DELEGATED OFFICER REPORT

WOKINGHAM
BOROUGH COUNCIL

Application Number:	252511
Site Address:	Hillside House, Basingstoke Road, Spencers Wood, Wokingham, RG7 1AP
Expiry Date:	22 January 2026
Site Visit Date:	12 December 2025
Proposal: Householder application for the proposed erection of a single storey side and rear extension with 1no. rooflight to replace existing ground floor structure, rear second storey external modifications and changes to fenestration.

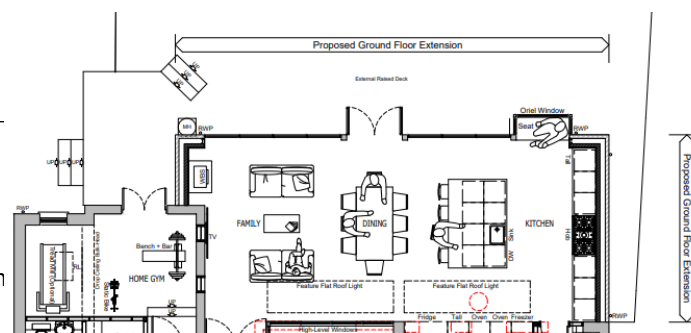
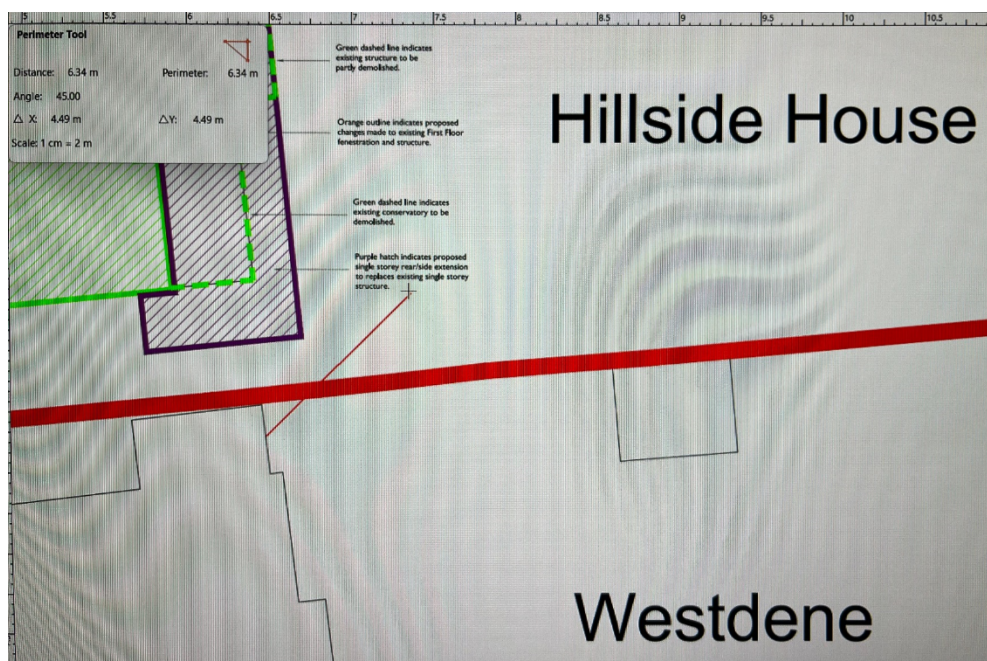
The first-floor rear window would now serve as a stairwell instead of a WC. The rear gardens of immediate neighbouring properties are already overlooked at an oblique angle from the upper floor windows in the host dwelling. Given the proposed first floor window would serve as a stairwell, such is classed as a non-habitable room where occupants wouldn't spend significant periods of time. Thus, the first-floor rear window would not cause any significant harm with regards to neighbouring amenities.

The minimum back-to-back separation distance set out in the BDG is 22m. The back-to-back separation distance between Hillside Houde and 15 Hilltop Gardens is over 29m, thus complying with the BDG.
